EXAMINATION REPORT - 50-395/OL-88-01

Facility Name: V. C. Summer Nuclear Station

Facility Docket No.: 50-395

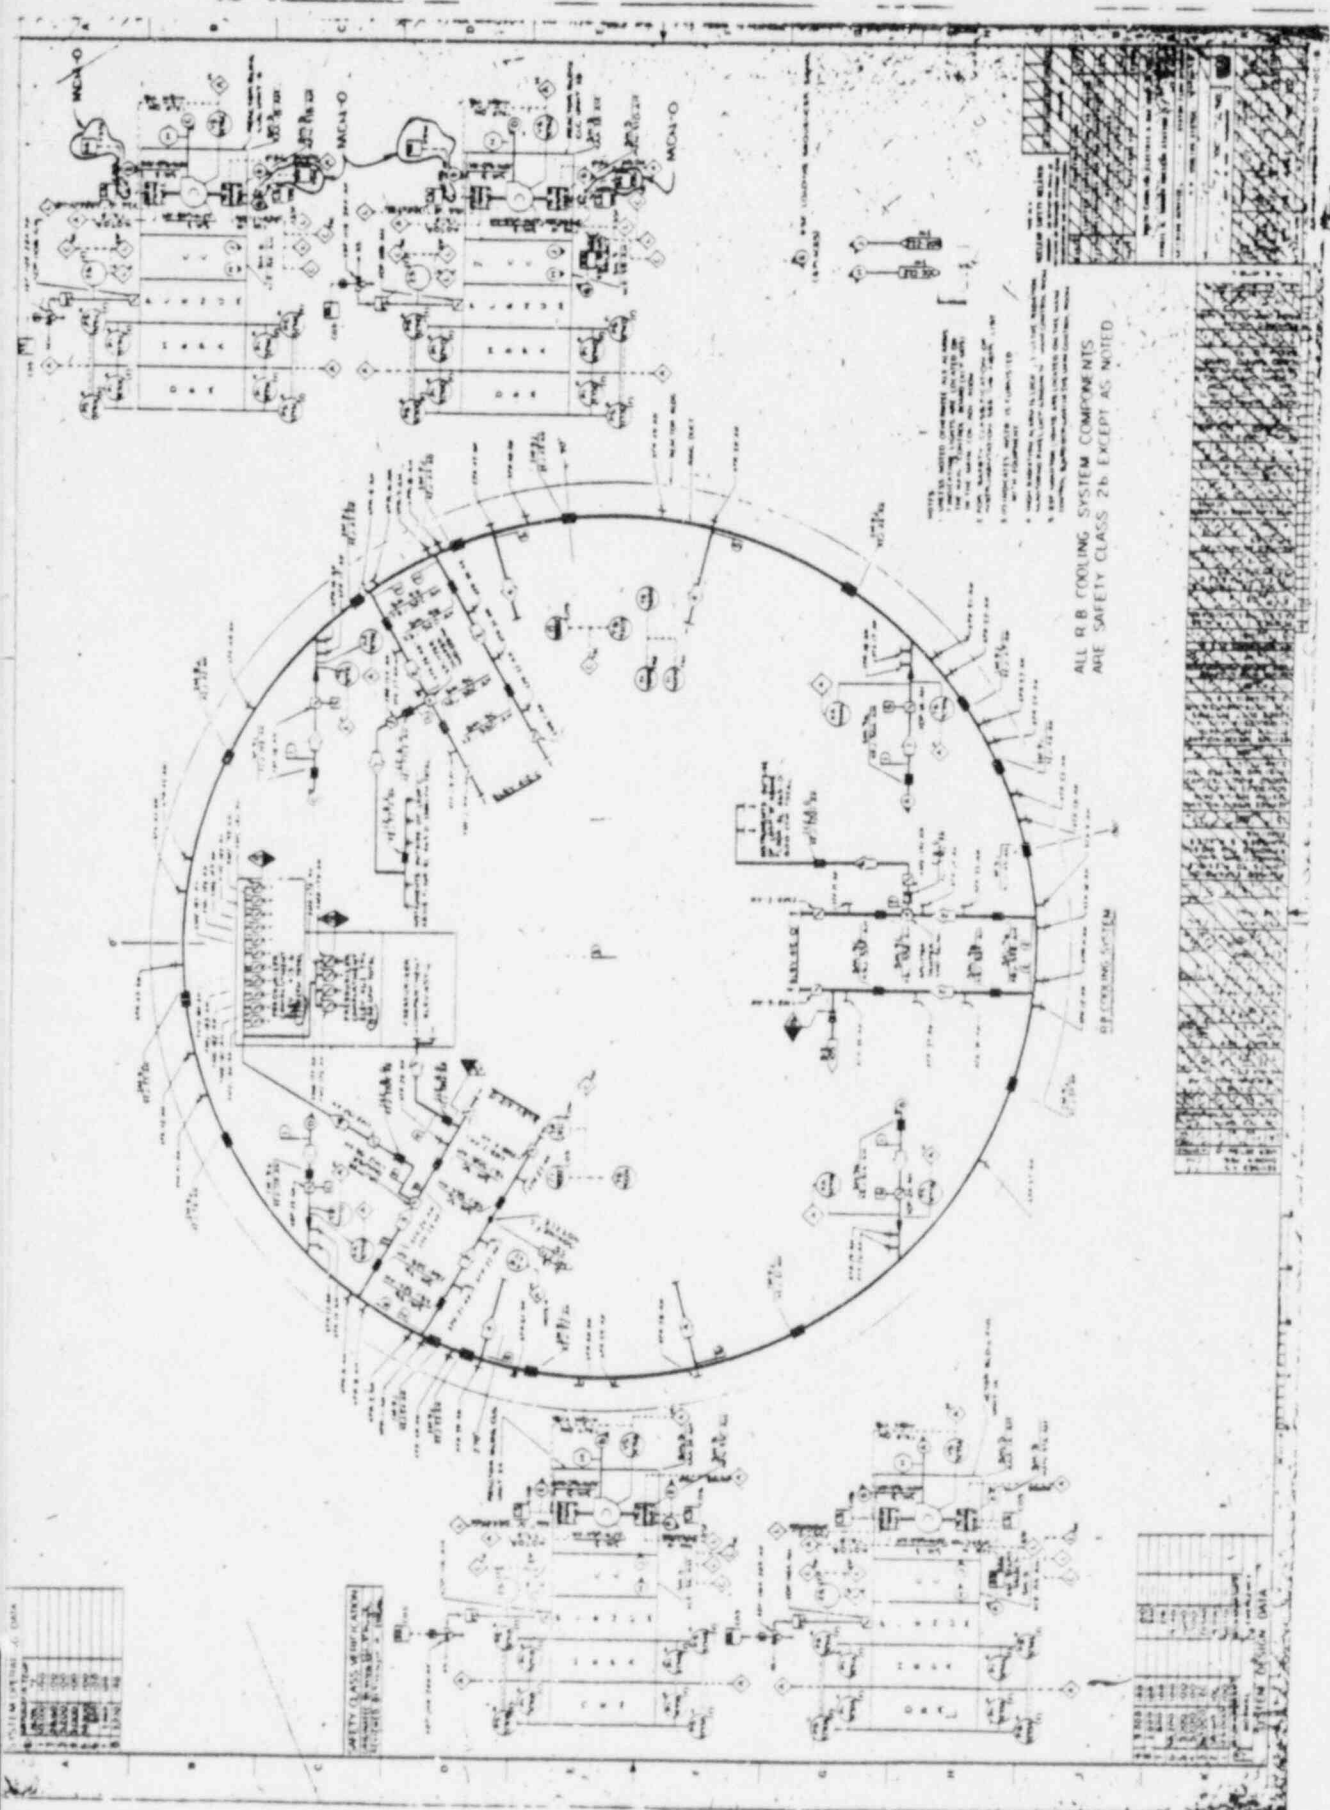
Selected fans (1 in each train) would start/shift to low speed (0.5) and service water system booster pumps start automatically (0.5) (Industrial cooling water supply to RBCU's isolates).

REASON: Main control board selector switches allow the operator to choose one fan in Train A and one in Train B for the RBCU's. Only these fans will shift to slow speed upon a safety injection signal. See attached drawing showing selector switches for each train.

Comment accepted. This was a CAF (Check at Facility) since information was not supplied to prepare the examination. Answer key modified as suggested.

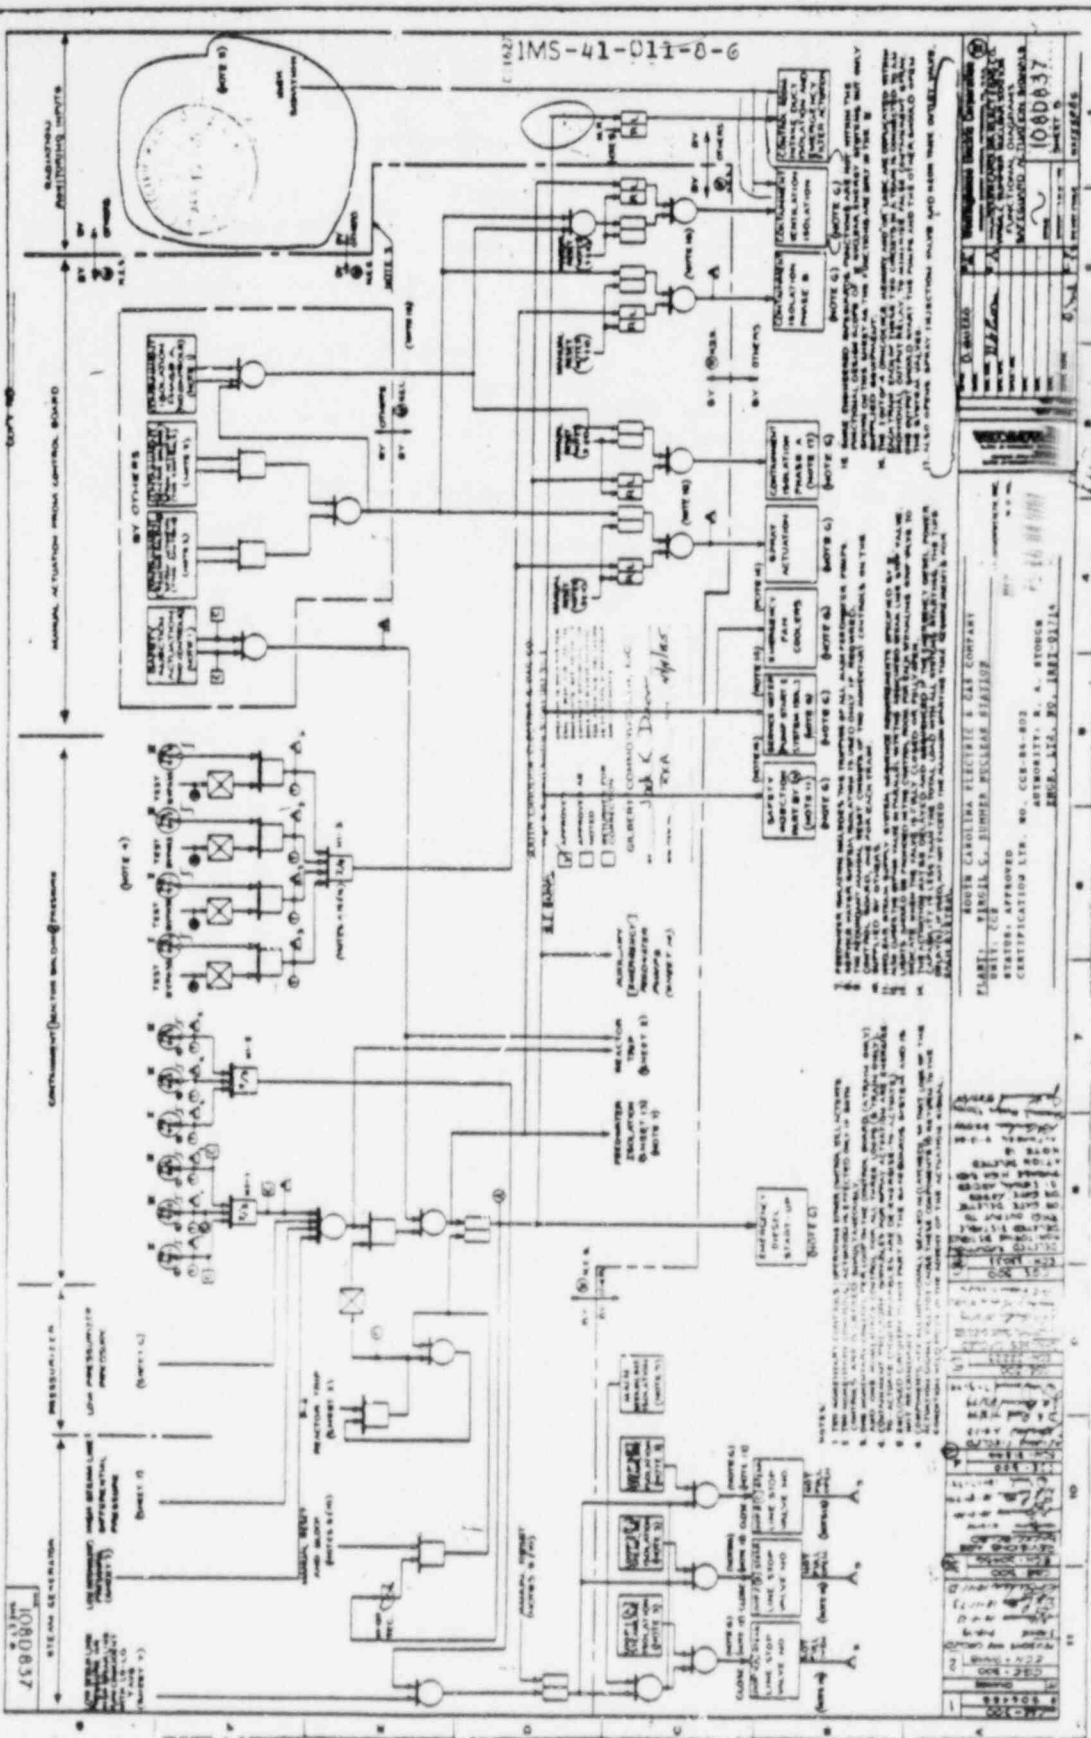
b. P-4 must be cleared. (It is cleared by closing the reactor trip breakers).

**REASON:** The intent of the answer key appears to be correct. The question asked only "what signal must be cleared". However, to provide clarification, a logic drawing is attached showing that the P-4 signal must be removed in order to enable a subsequent auto SI signal. The P-4 signal is cleared by closing the reactor trip breakers.

Comment noted. Either response will be given full credit since the action to clear P-4 is to close the reactor trip breakers. No change to the answer key is required.
